Staff Report to the Plan Commission

Valvoline Instant Oil Change

Project: 2025-0321 – Valvoline Instant Oil Change - 179th & Wolf Road**Planner:** Rob Fischer**Petitioner/Representative:** Dan Elliott**Location:** 11320 179th Street**P.I.N.s:** 27-31-202-019-0000**Parcel Size:** 82,915.15 SF

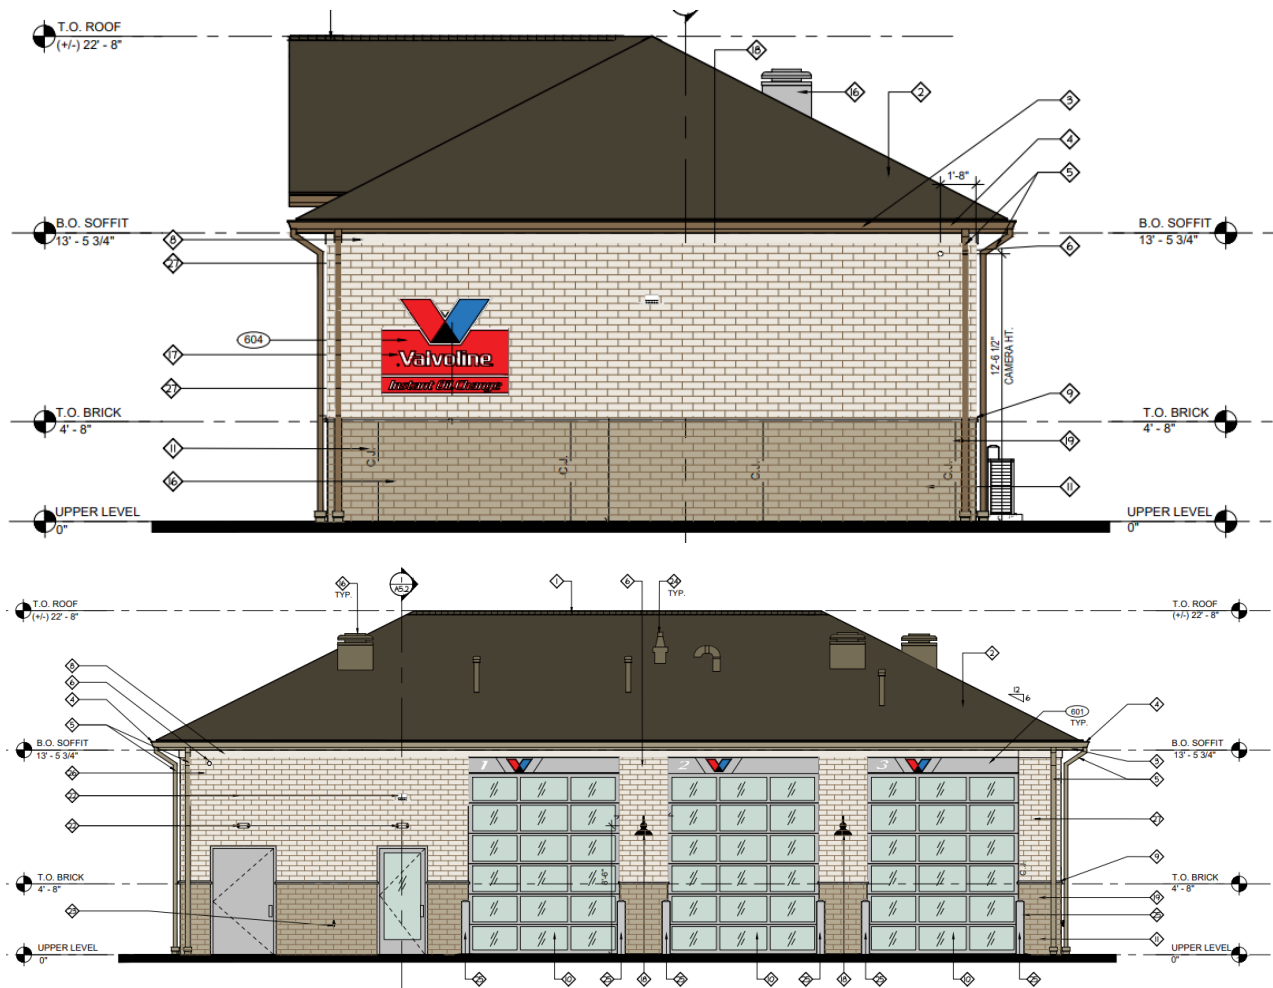
During the review of this case, it was discovered 3 site plan items need to be addressed. The petitioner is preparing a revised site plan, and it will be presented at the meeting on Tuesday, November 18. If the petitioner needs additional time or the revisions need further refinement, a request to continue the case may be requested by staff.

The impervious area of building and pavement is 18,915 SF and the lot area is 23,790 SF. The lot coverage is 80%, which is more than the maximum allowable coverage of 75%, so the requirement is not met.

Each Automotive Repair Facility lot is required to have one off-street parking space per 300 SF of building area, per LDC Table 6-306(B). For this proposed 1,740 SF building, the minimum number of required parking spaces is 6. The site plan has 13 parking spaces, including 1 accessible space; therefore, the requirement is met.

PRELIMINARY LANDSCAPE PLAN

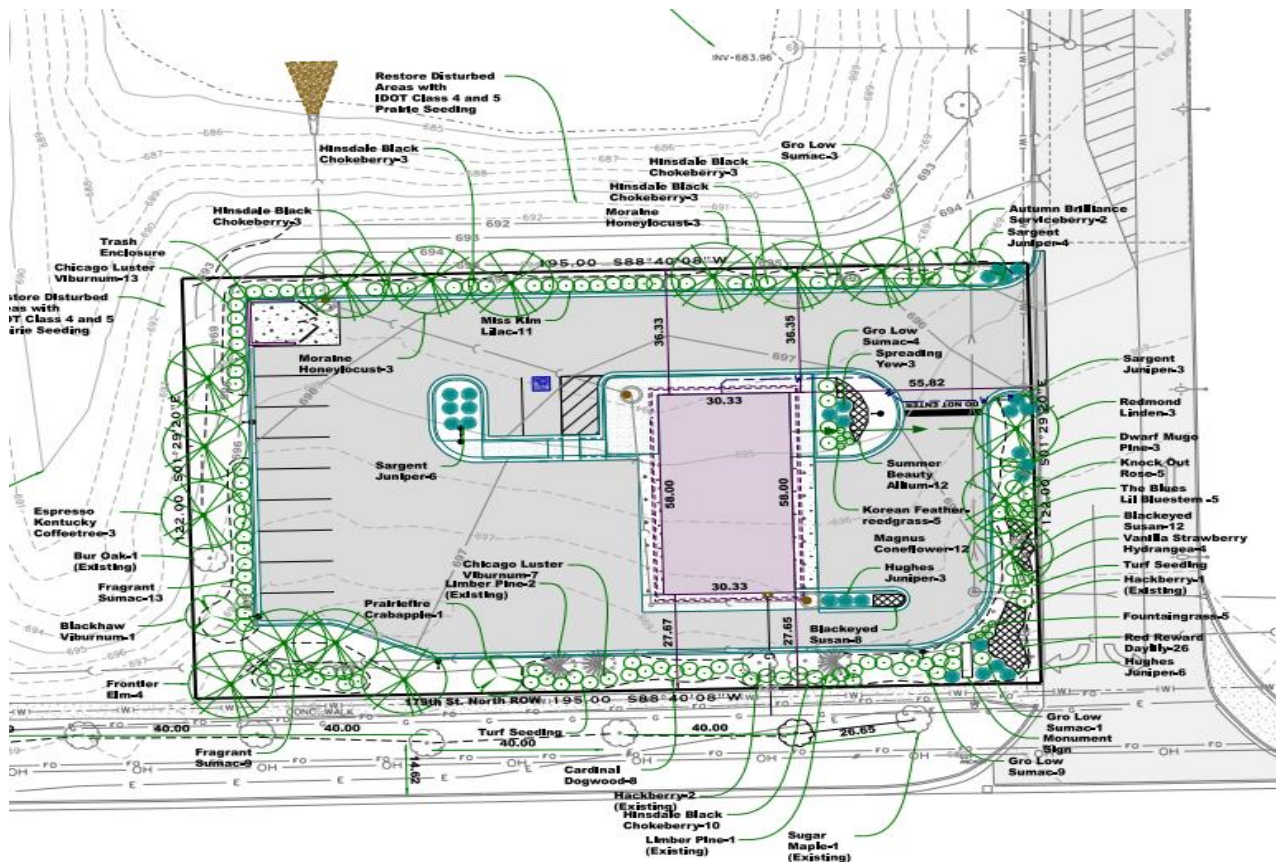
The preliminary landscape plans are compliant with the Land Development Code apart from the required maintenance access path for the Lot 1 detention basin, for which the petitioner is seeking a variance. LDC Section 6-305.D.8.b.4 calls for a maintenance vehicle access area (which) shall be provided around the pond, at least 8' wide not exceeding a 2% cross slope and shall remain open and accessible for maintenance purposes, planted with native low-growing plant materials or as a recreational/maintenance trail.

Per LDC Section 5-109, the petitioner has provided responses to standards applicable to all variances. Any outstanding comments must be completed during the final landscape review. The representative plant list appears to meet diversity requirements for number of species, and the percentage of species will be evaluated during the final landscape plan review. The petitioner states meeting the requirement is cost prohibitive and that maintenance staging may utilize the Valvoline site.

1. A Variance to allow the omission of the maintenance access path for the site detention basin.
